**THE IMPROVEMENTS ON
HAVILAND AVENUE
FROM MEDFORD AVENUE TO BLOSSOM WAY
CHERRYLAND, ALAMEDA COUNTY, CALIFORNIA
SPECIFICATION NO. 2449**

TO ALL PROSPECTIVE BIDDERS for the above project, notice is hereby given that the following changes, modifications, corrections, clarifications, and additions as hereinafter set forth shall apply to the plans and specifications described herein and shall be made part thereof and subject to all requirements as if originally specified or drawn.

1. Replace Plan Sheet 7 with the attached Plan Sheet 7 (Revision 1)
2. Replace Plan Sheets 15 thru 17 with the attached Plan Sheets 15 (Revision 1) thru 17 (Revision 1)

THE IMPROVEMENTS ON
HAVILAND AVENUE
FROM MEDFORD AVENUE TO BLOSSOM WAY
UTILITY PLAN

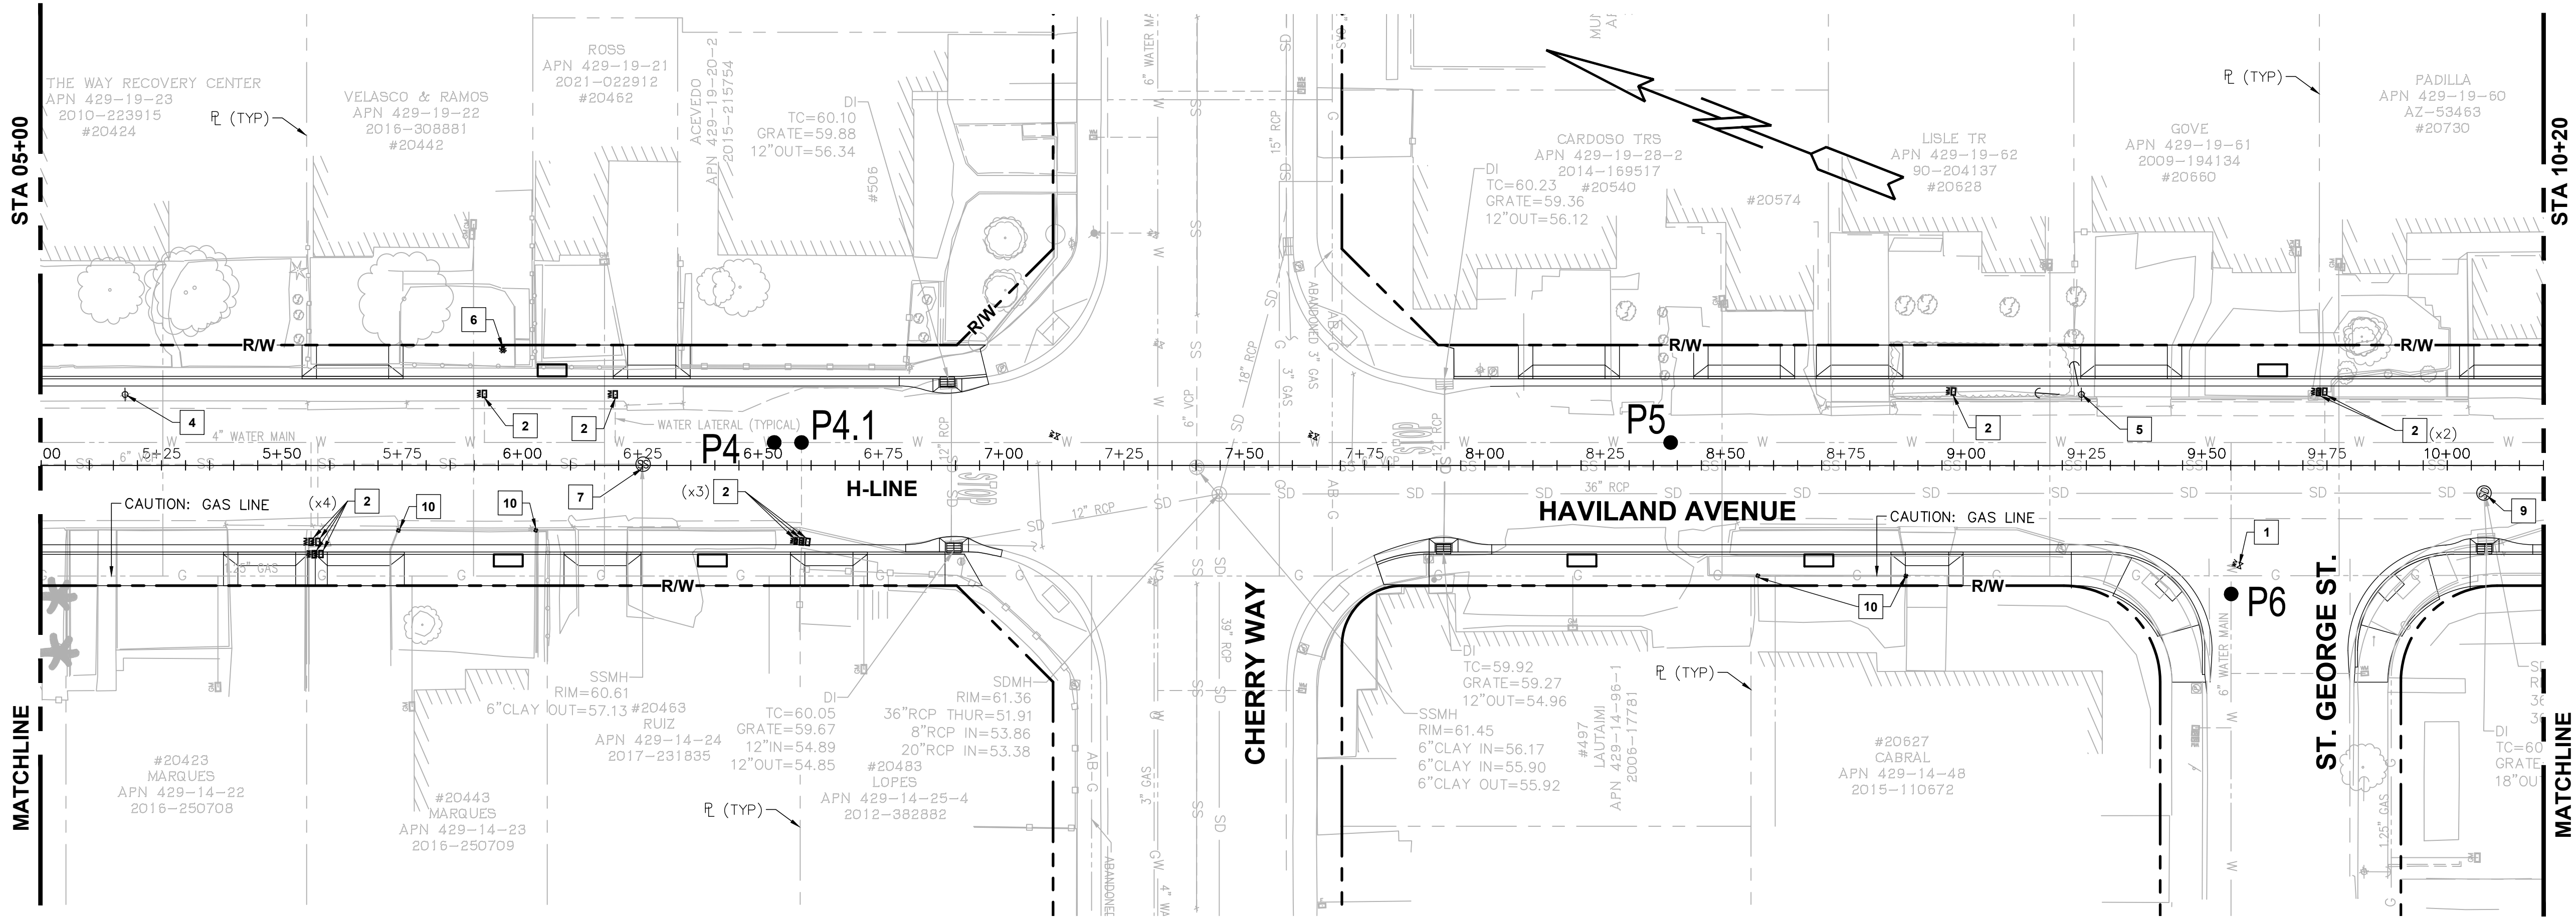
NO.	DESCRIPTION	BY	DATE
11	REVISED KEYNOTE	EK	11/7/25
AL			APPROVED

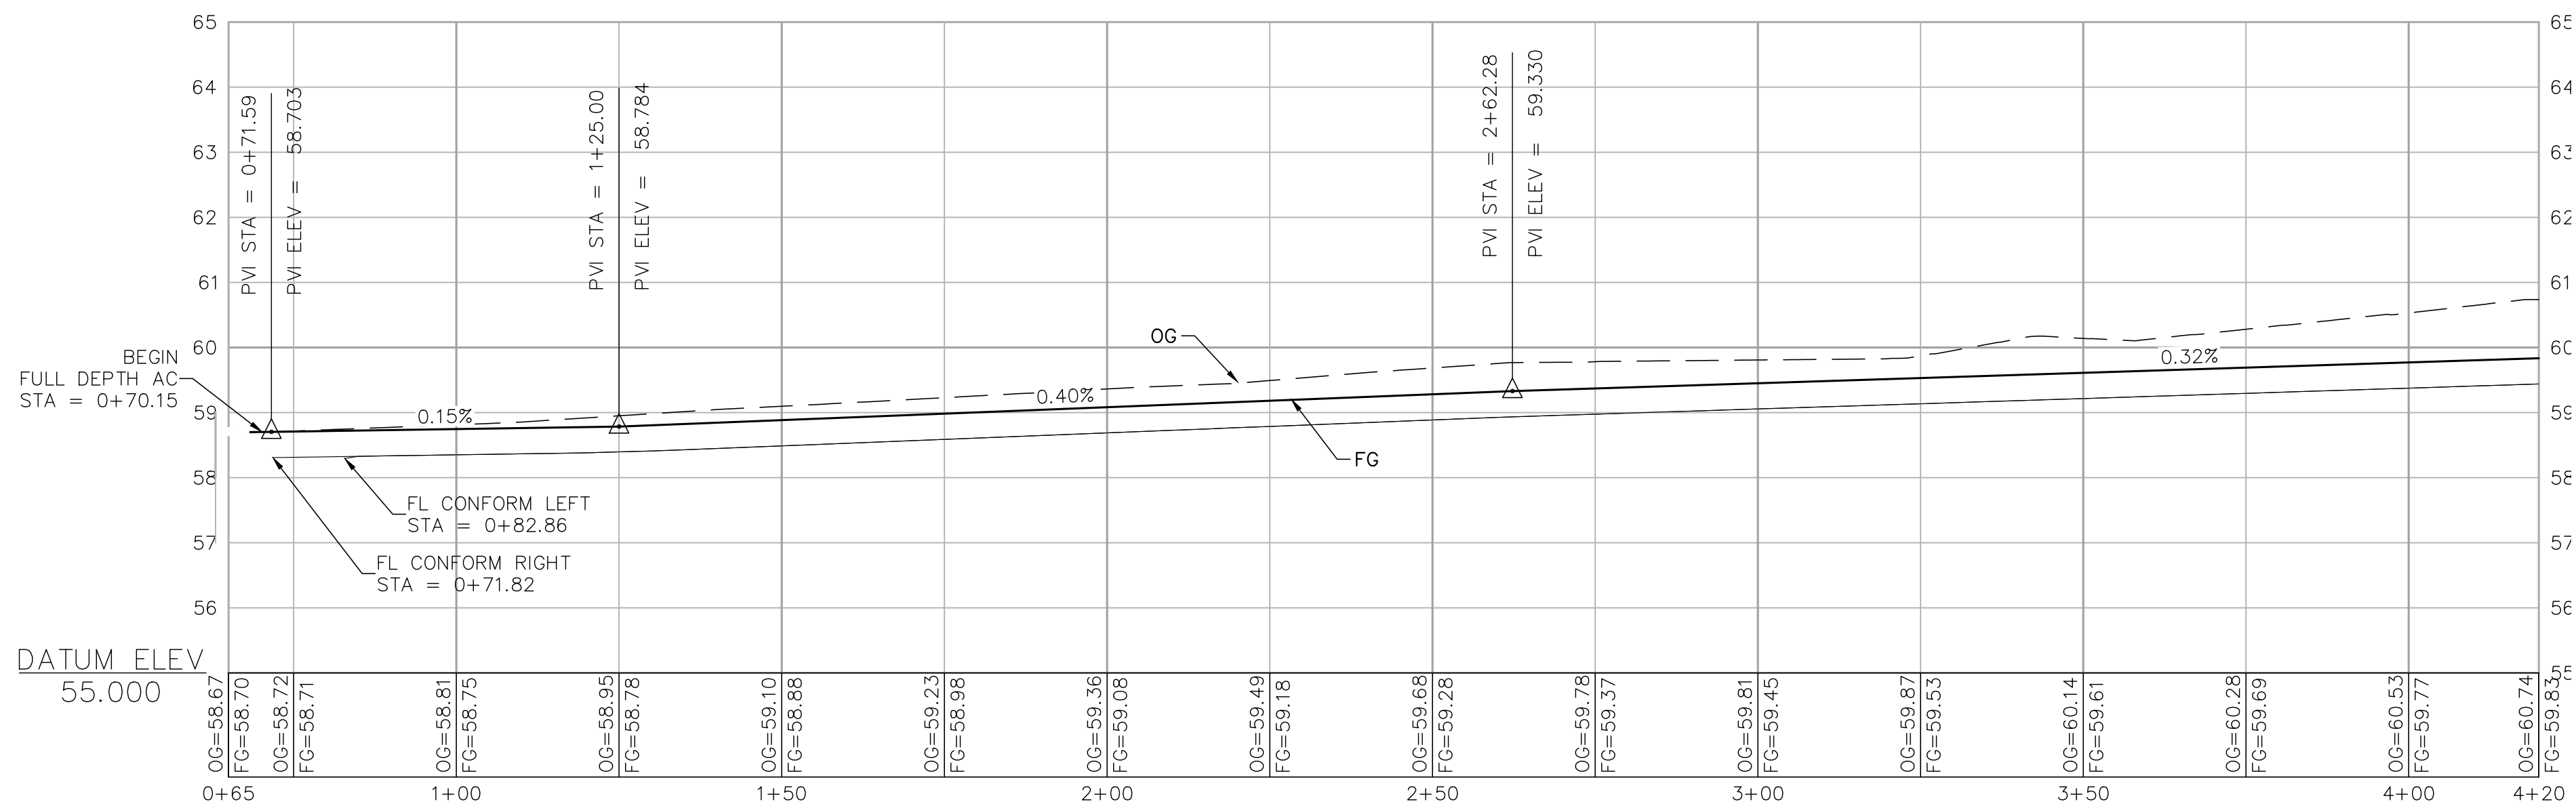
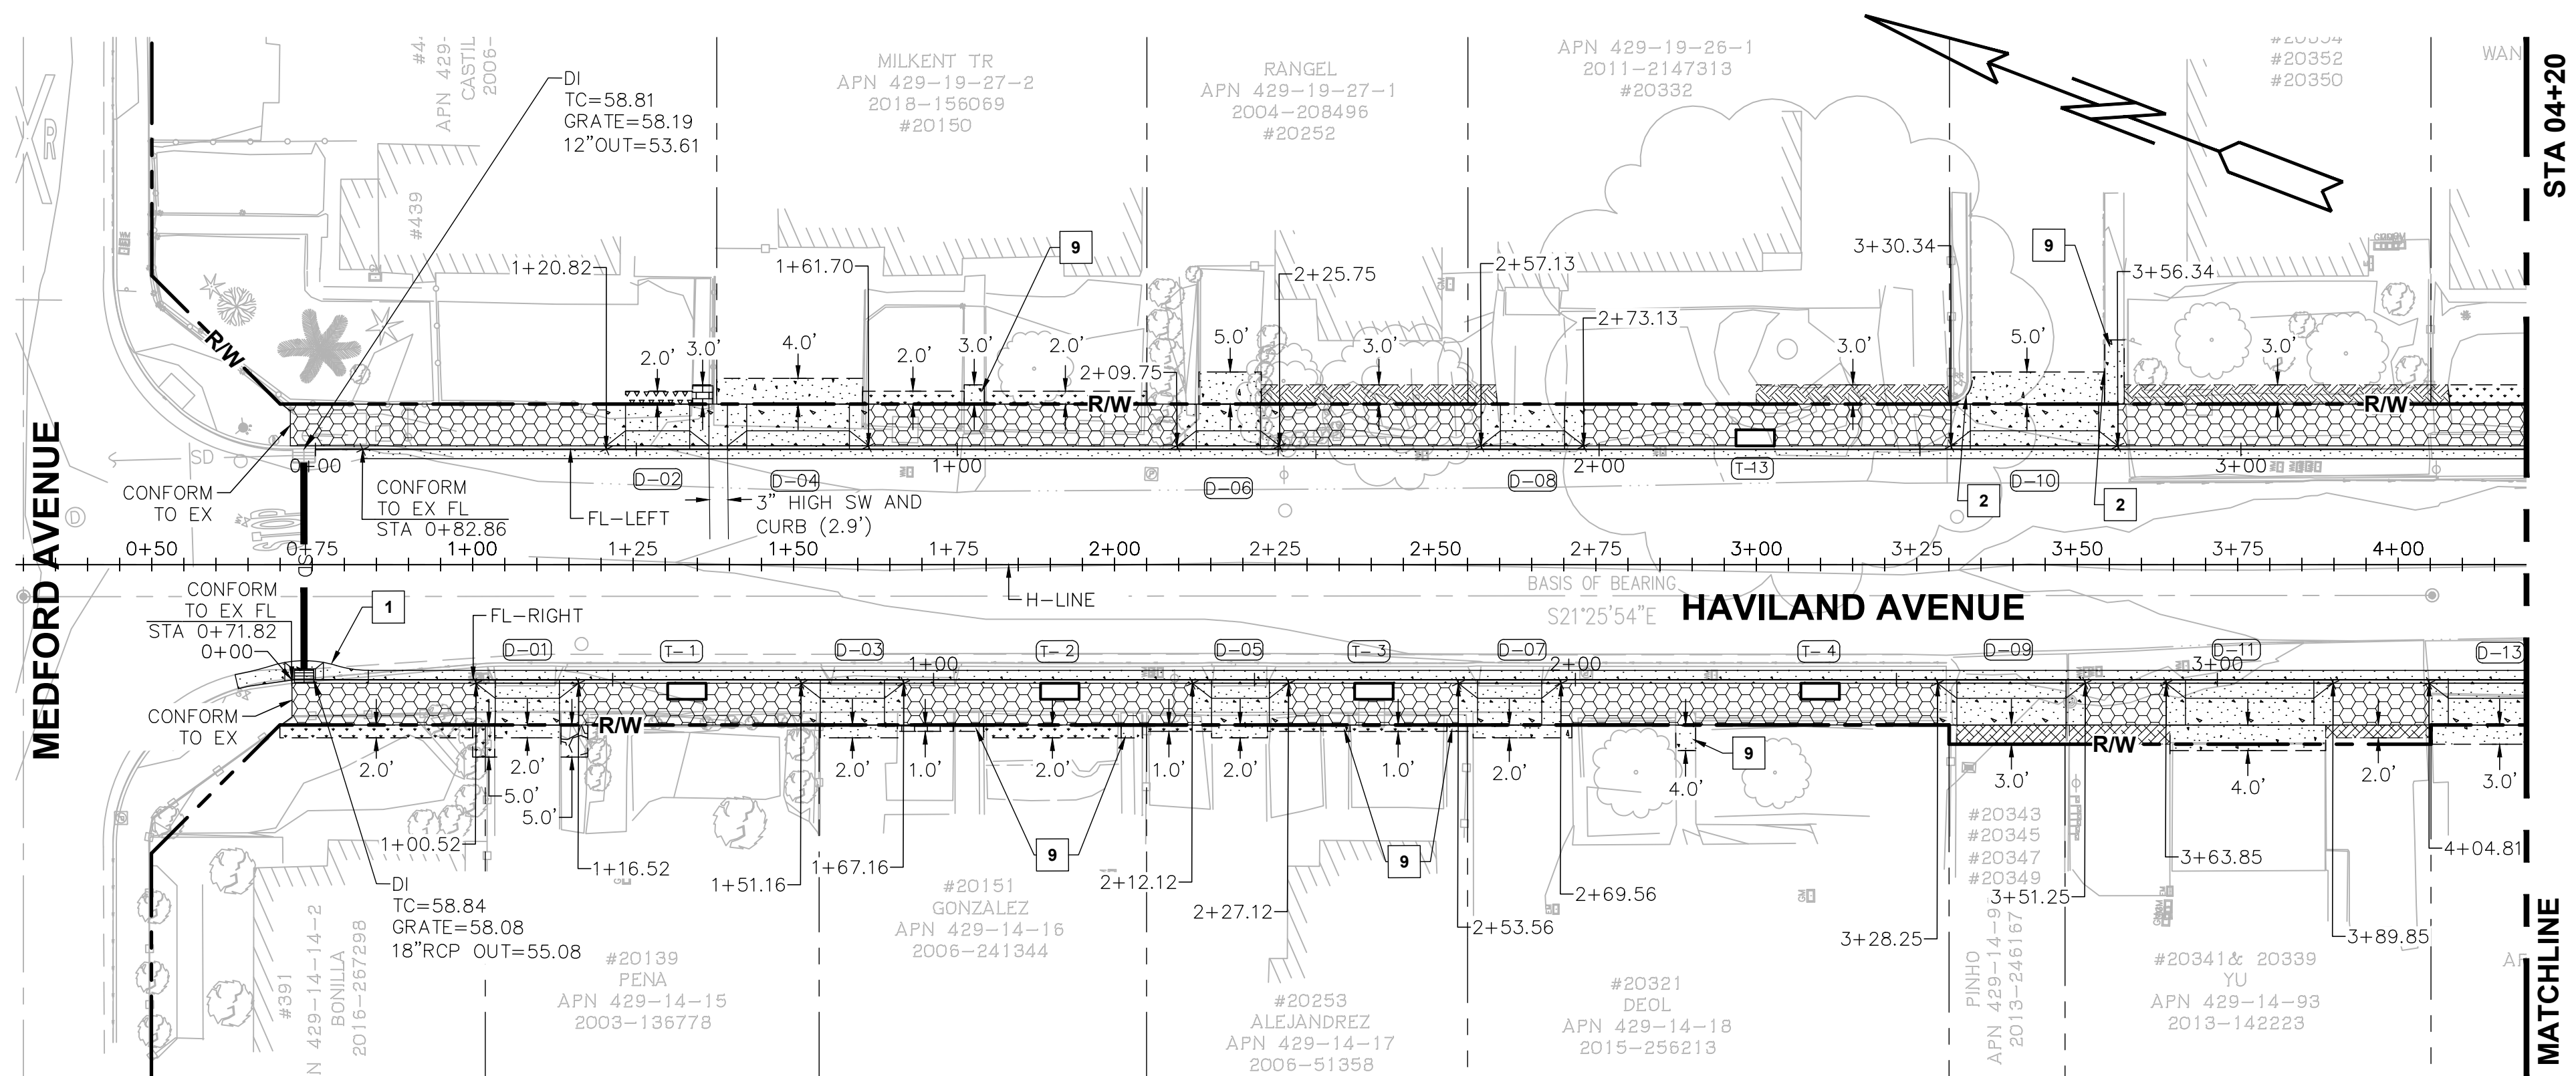
REVISIONS				
NO.	DESCRIPTION	BY	DATE	APP'D
1	REMOVED GENERAL NOTE: CALLOUT	EK	11/7/25	AL
2				
3				
4				
5
